# PERMIT

SEWAGE DISPOSAL SYSTEM  
HOWARD COUNTY HEALTH DEPARTMENT  
BUREAU OF ENVIRONMENTAL HEALTH  
410-313-2640

SUBDIVISION River Farms Inc. LOT NUMBER A ADDRESS 15897 A.E. Mullinix Road

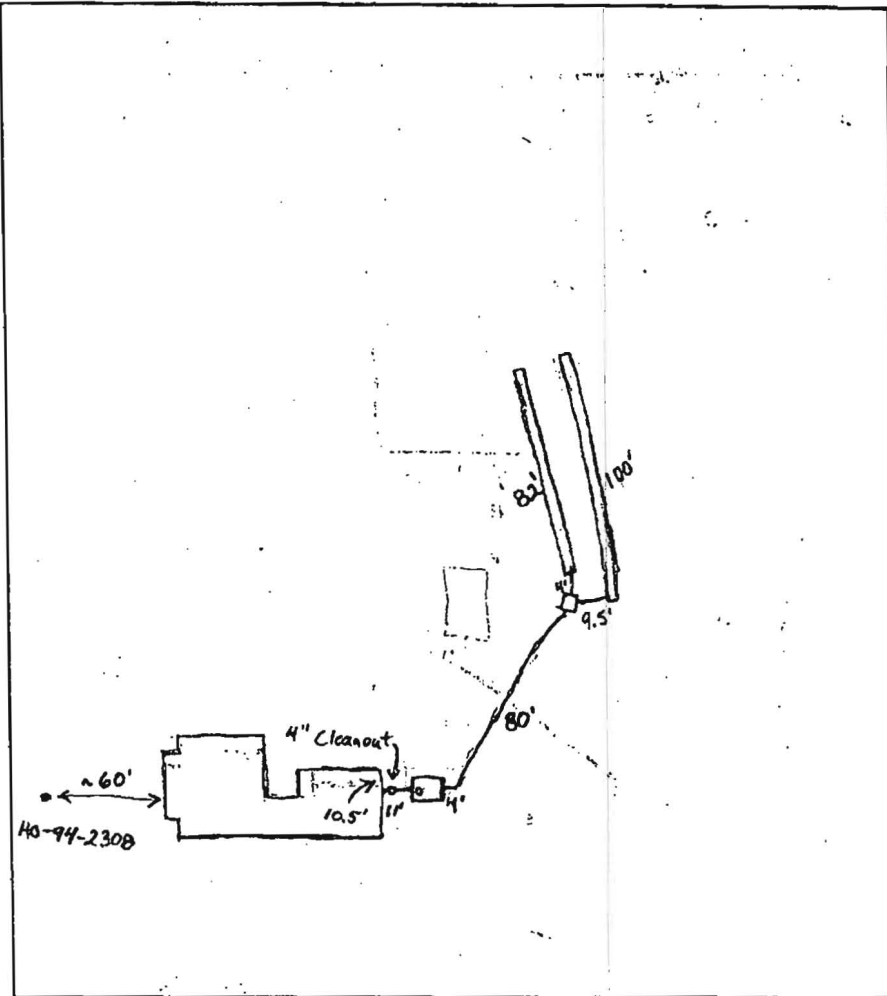
PRE-CONSTRUCTION INSPECTION: TANK NOT YET ON SITE. 2 90' TRENCHES TO BE

INSTALLED AT HIGH EDGE OF SEPTIC. SLIGHT ADJUSTMENT FROM CONTOUR

OK TO WORK AROUND EXISTING TREES. 10/13/00 (CW)

10/13/00 SEPTIC TANK OK TO COVER (NO NEED FOR MANHOLE RISER - LESS THAN 18" BELOW GROUND) (CW)

10/16/00 House connection made. Trenches 10' apart near box in order to avoid tree. Separation increases farther down trenches. Everything satisfactory. O.K. to cover. (BB)
